HISTORIC AND DESIGN REVIEW COMMISSION

September 20, 2023

HDRC CASE NO: 2023-368
ADDRESS: 102 BUFORD
LEGAL DESCRIPTION: NCB 1369 BLK 6 LOT N 83 FT OF 11
ZONING: R-4, H
CITY COUNCIL DIST.: 2
DISTRICT: Dignowity Hill Historic District
APPLICANT: Peter K Wolfgram
OWNER: Peter K Wolfgram
TYPE OF WORK: Roofing replacement from standing seam metal to composition shingle
APPLICATION RECEIVED: August 28, 2023
60-DAY REVIEW: October 27, 2023
CASE MANAGER: Bryan Morales

The applicant is requesting a Certificate of Appropriateness for approval to replace the existing standing seam metal roof with a composition shingle roof.

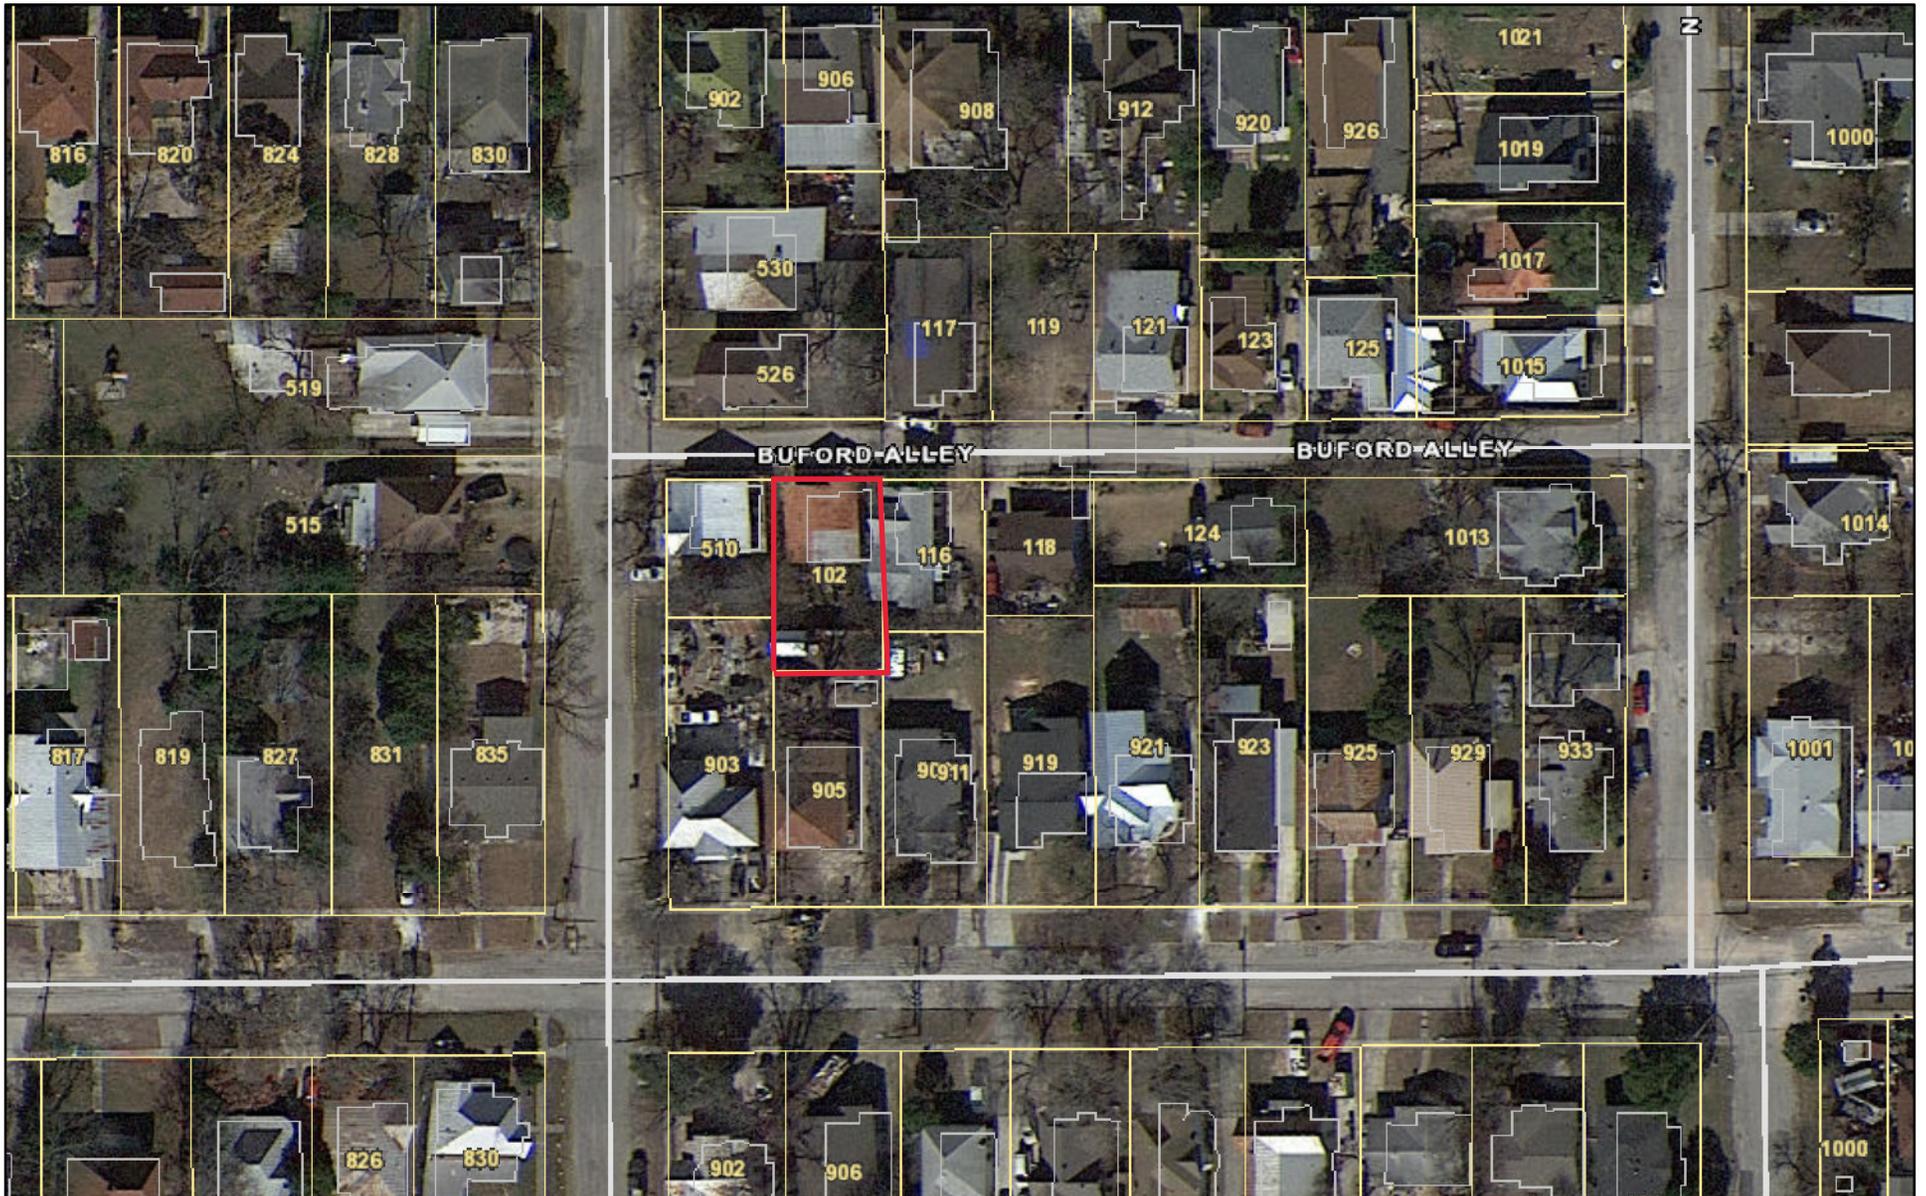
- a. The primary structure located at 102 Buford is a one-story, single-family residence in the Craftsman style constructed c. 1934 and first appears in the 1934 Sanborn map. The structure features two, front-facing standing seam metal gables, wood windows, a front porch with square wood columns, and the roof features rafter tails. This property contributes to the Dignowity Hill Historic District.

- b. ROOF REPLACEMENT – The applicant is requesting to remove the existing standing seam metal roof and replace it with a composition shingle roof. The Historic Design Guidelines for Exterior Maintenance and Alterations 3.B.vi. states to use metal roofs on structures that historically had a metal roof or where a metal roof is appropriate for the style or construction period. The 1934 Sanborn map confirms that the structure originally had a non-combustible roof. Staff finds the removal of the standing seam metal roof in favor of a composition shingle roof generally appropriate.

Staff recommends approval of the request, based on findings a and b.
